**5000140980-Williams Playlot & ADA Parking 7744 Mistletoe Street,  
Metairie, La 70003 Project No 20-2142 Department of Recreation  
Jefferson Parish Government**

JEFFERSON PARISH DEPARTMENT OF PARKS AND RECREATION  
BID PROPOSAL NO. 50-00140980  
ADDENDUM #2  
MARCH 8, 2023  
PAGE 1 OF 15

ADDENDUM NO. 2

A/E PROJECT NO. 20-2142  
PROPOSAL NO. 50-00140980

**WILLIAMS PLAYLOT & ADA PARKING**  
 JPRD, OWNER

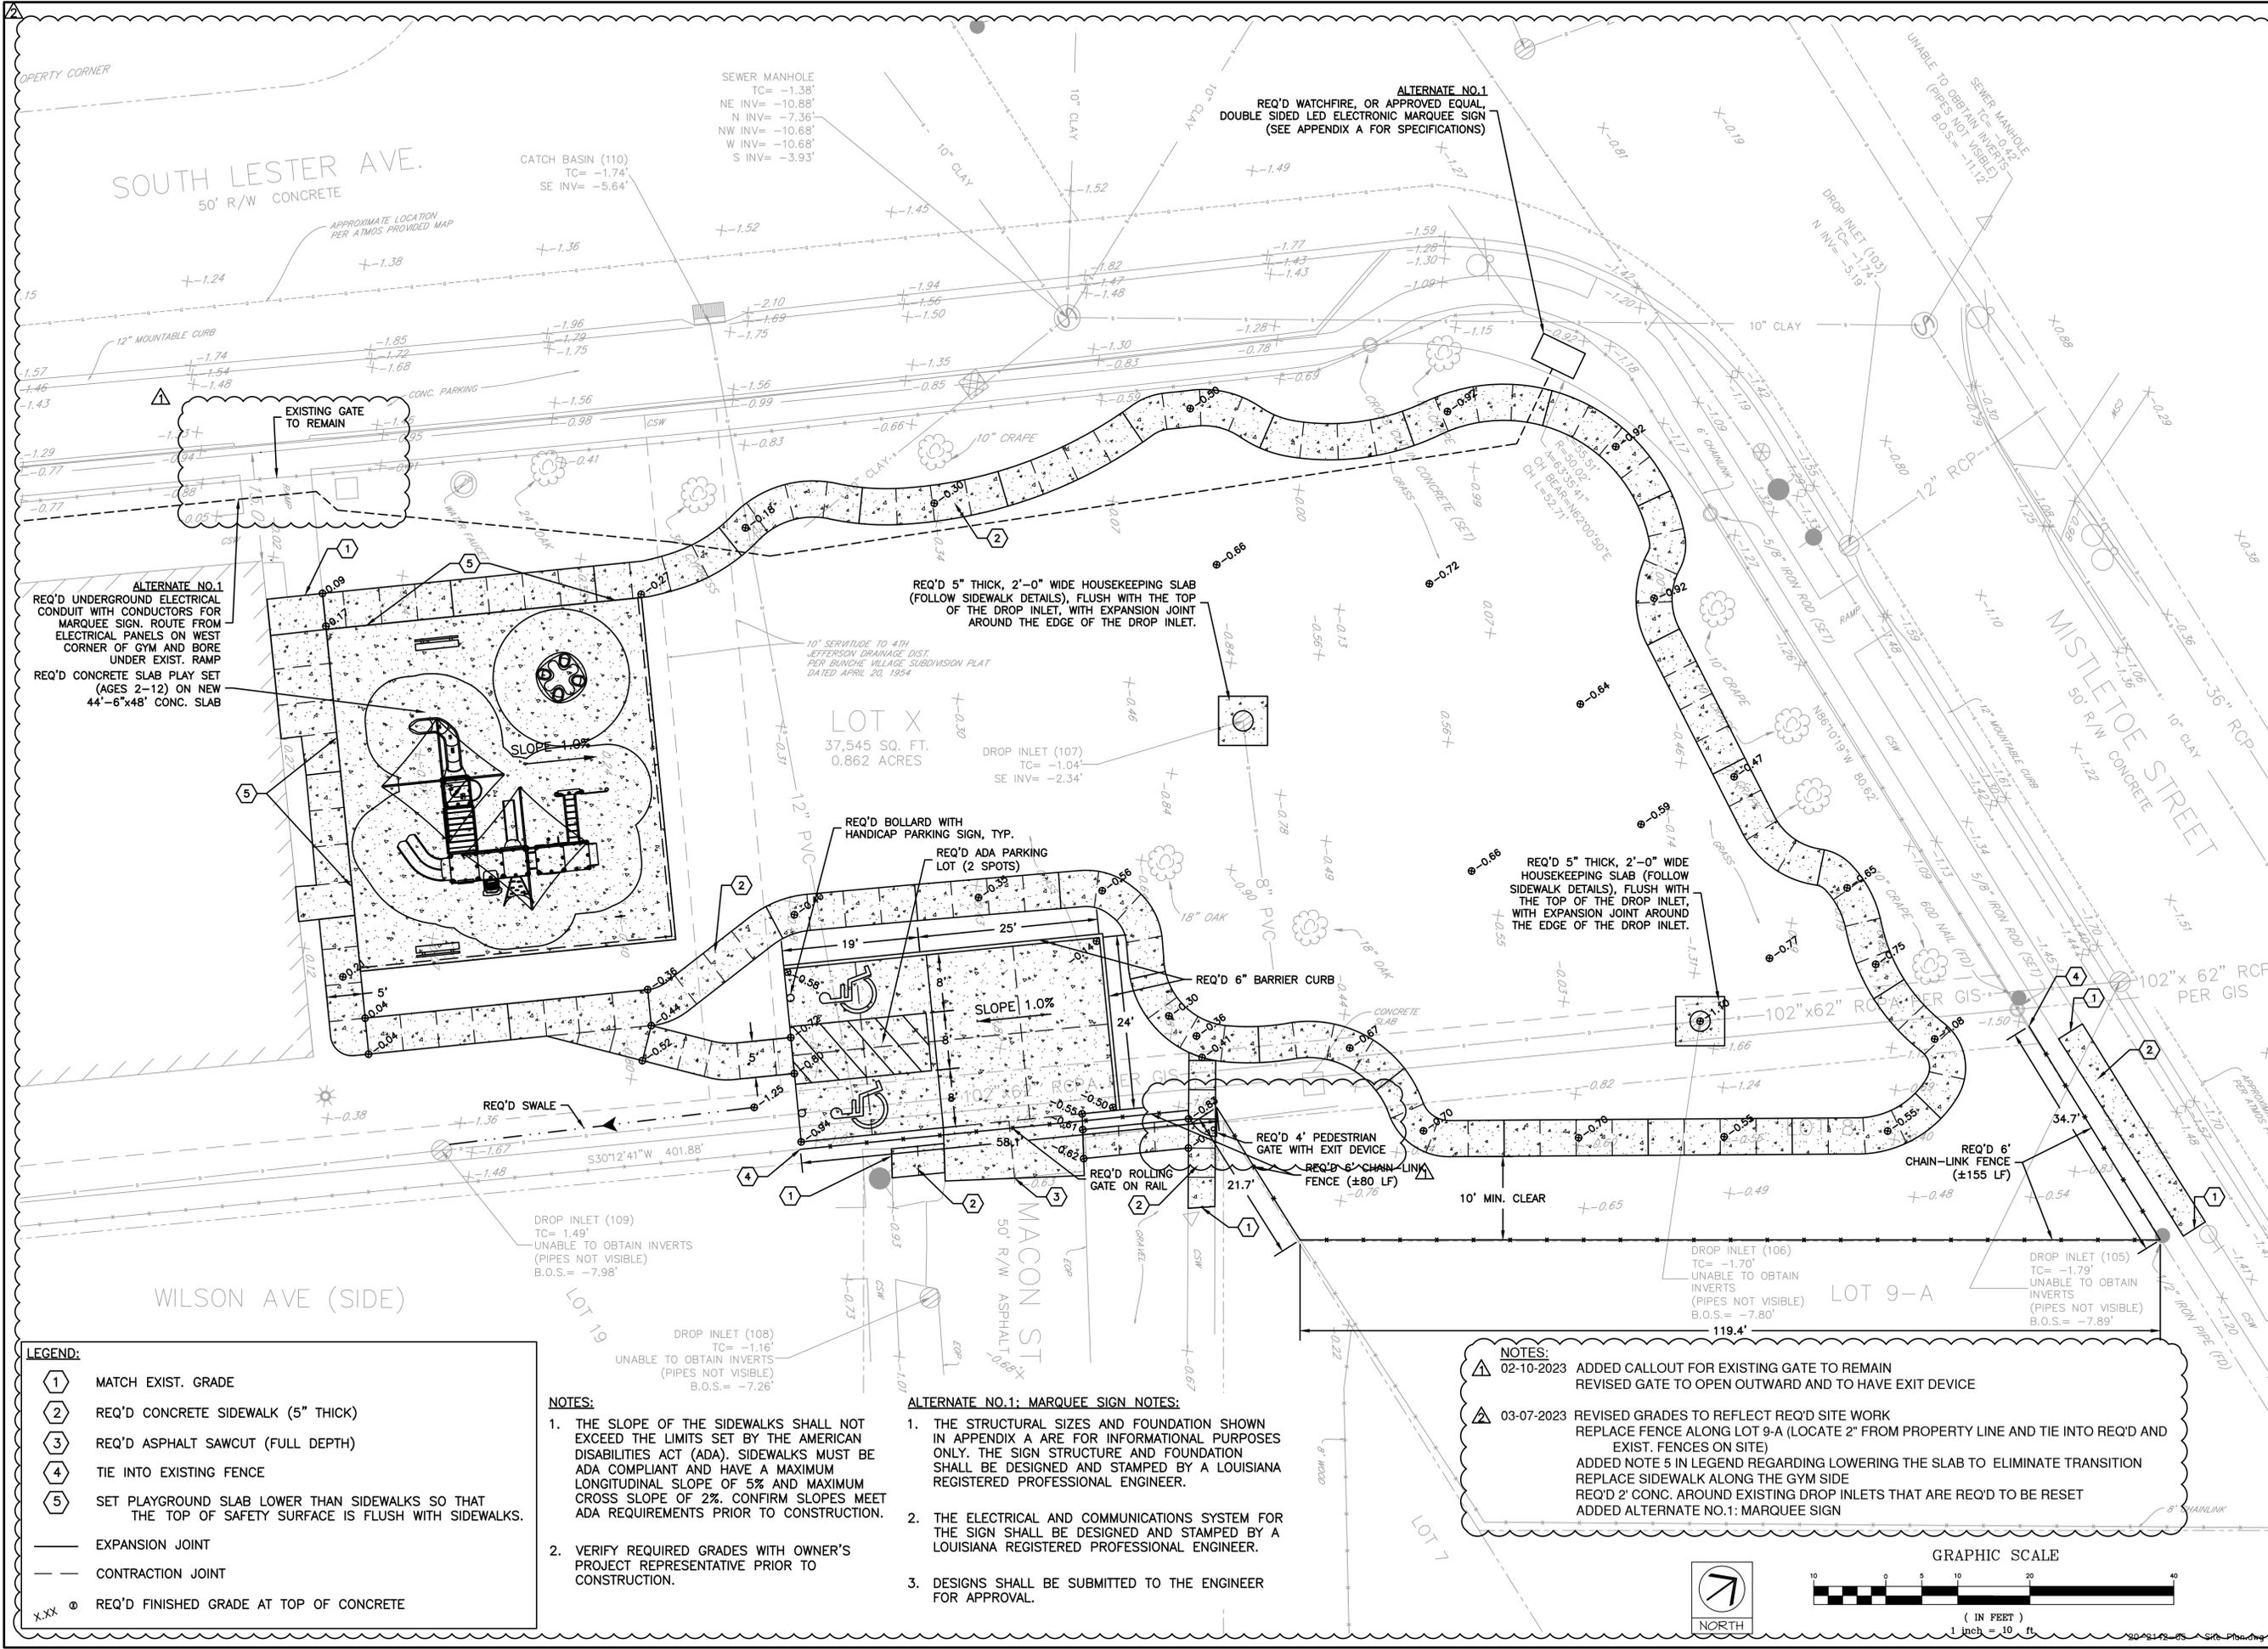
Q. I noticed that on the plans you require us to meet the grade of the existing sidewalk outside of the gym door, however if you look at the state of the existing sidewalk it is cracked and has several dips in it. Would it be possible to remove the existing sidewalk and bring the playground slab all the way to the building? It would add approx. 500 sq ft and give a better finish then just tying in to the existing sidewalk.

Q. In regards to the pour in place rubber surfacing are you looking to have it gradually sloped up from the edge around the entire playground so as to not have a tripping hazard or are you wanting the slab set lower in the ground as to allow for a smooth transition from the sidewalk to the playground?

Q. Will we be raising the existing drains to meet the new grade should they call for it?

- 02-10-2023 ADDED CALLOUT FOR EXISTING GATE TO REMAIN  
 REVISED GATE TO OPEN OUTWARD AND TO HAVE EXIT DEVICE
- 03-07-2023 REVISED GRADES TO REFLECT REQ'D SITE WORK  
 REPLACE FENCE ALONG LOT 9-A (LOCATE 2' FROM PROPERTY LINE AND TIE INTO REQ'D AND EXIST. FENCES ON SITE)  
 ADDED NOTE 5 IN LEGEND REGARDING LOWERING THE SLAB TO ELIMINATE TRANSITION  
 REPLACE SIDEWALK ALONG THE GYM SIDE  
 REQ'D 2' CONC. AROUND EXISTING DROP INLETS THAT ARE REQ'D TO BE RESET  
 ADDED ALTERNATE NO.1: MARQUEE SIGN

**A. *Revisions were made to the plan sheets attached to this Addendum.***

**A. *Revisions were made to the plan sheets attached to this Addendum.***

**A. *Revisions were made to the plan sheets attached to this Addendum.***

- ① MATCH EXIST. GRADE
- ② REQ'D CONCRETE SIDEWALK (5" THICK)
- ③ REQ'D ASPHALT SAWCUT (FULL DEPTH)
- ④ TIE INTO EXISTING FENCE
- ⑤ SET PLAYGROUND SLAB LOWER THAN SIDEWALKS SO THAT THE TOP OF SAFETY SURFACE IS FLUSH WITH SIDEWALKS.

PLAYGROUND EQUIPMENT PLAN  
**WILLIAMS PLAYLOT & ADA PARKING**  
**JPRD, OWNER**

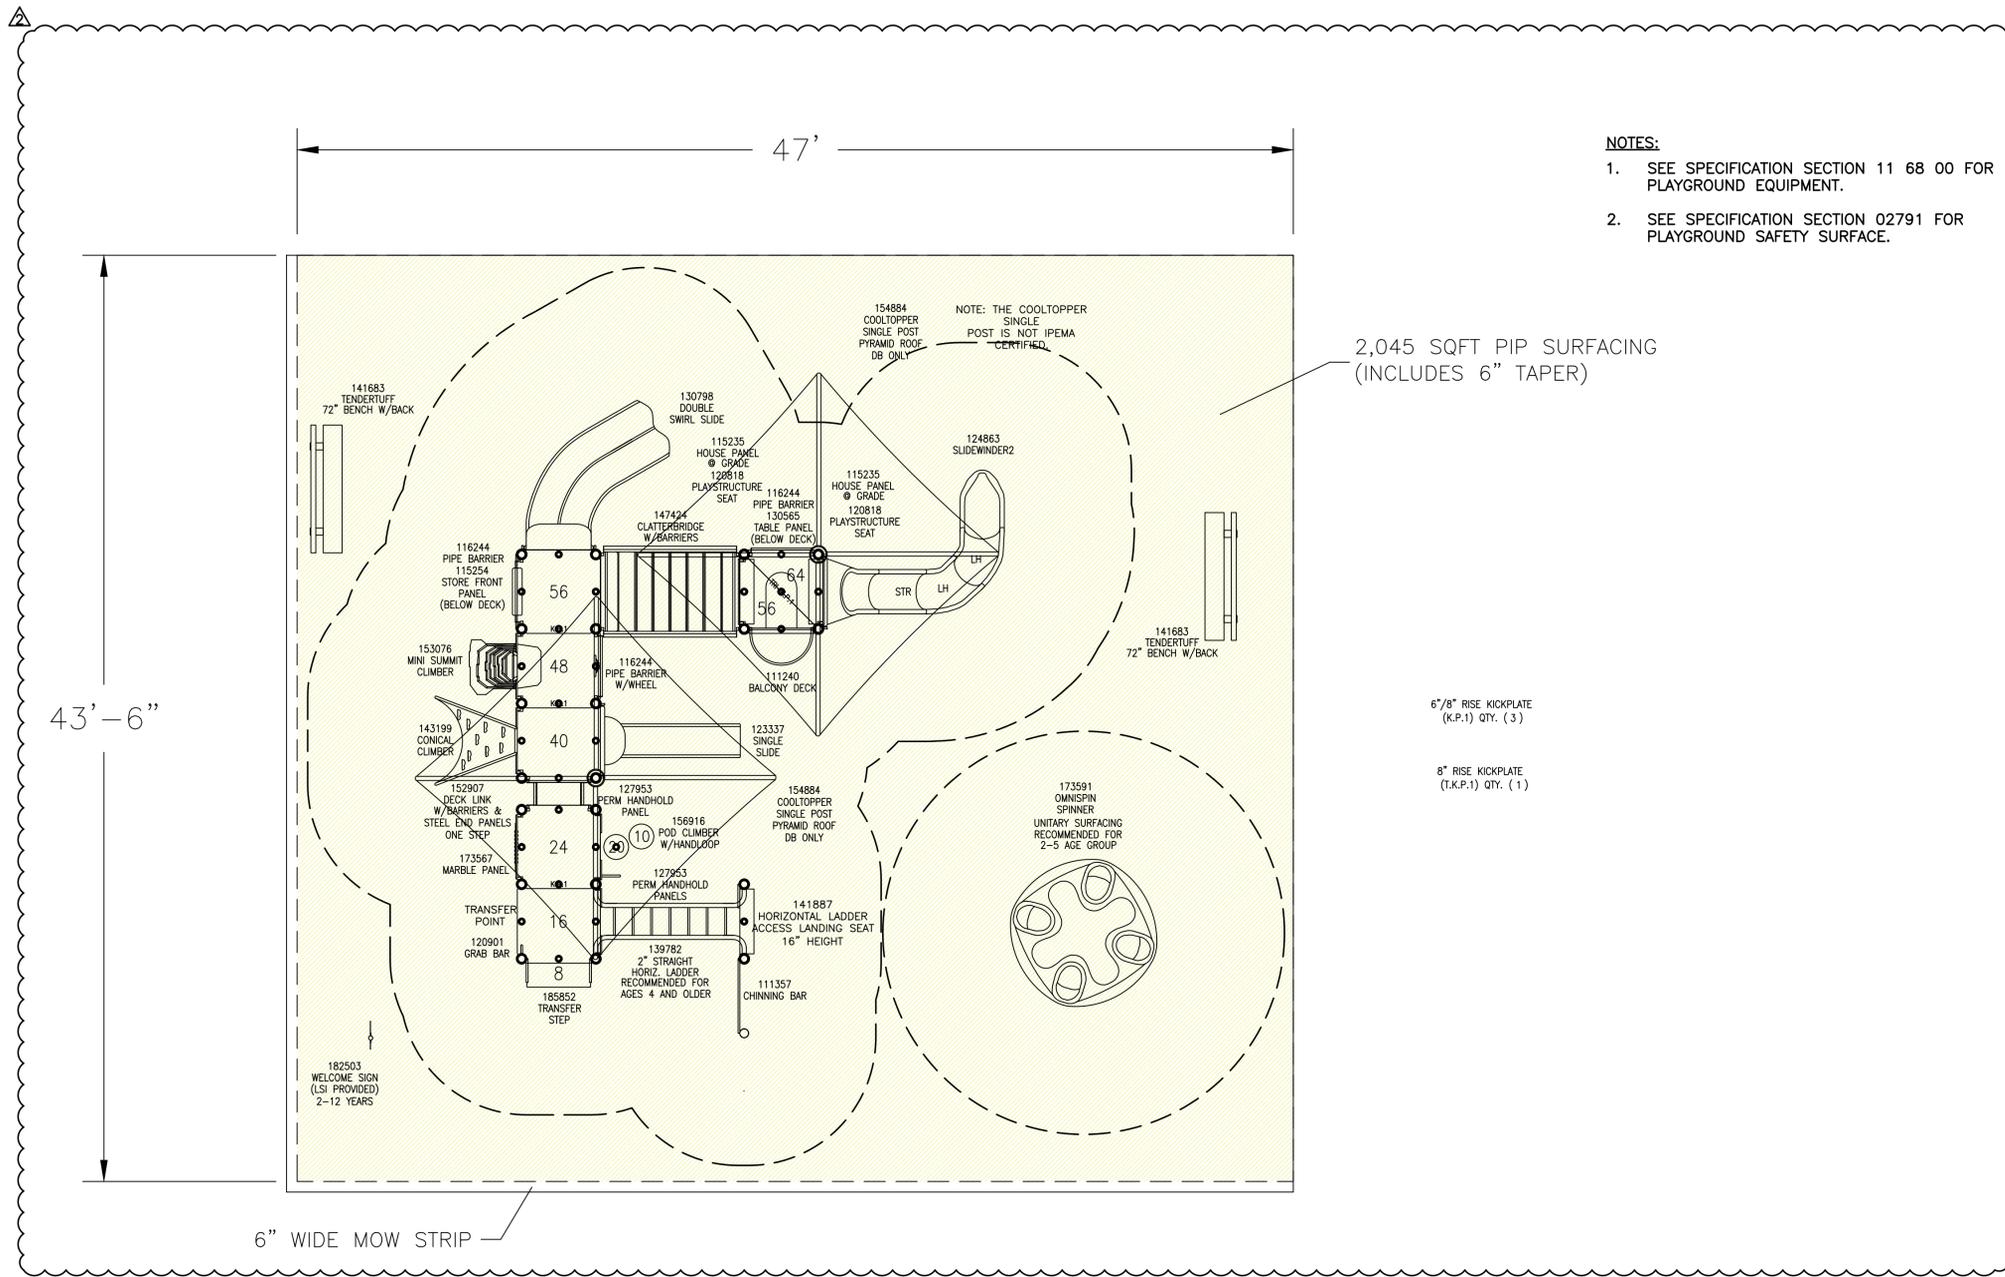
NOTES:  
 03-07-2023 REMOVED PLAY AREA TRANSITION/RAMP  
 REMOVED MOW STRIP ON SIDES THAT WILL BE FLUSH W/ SIDEWALK
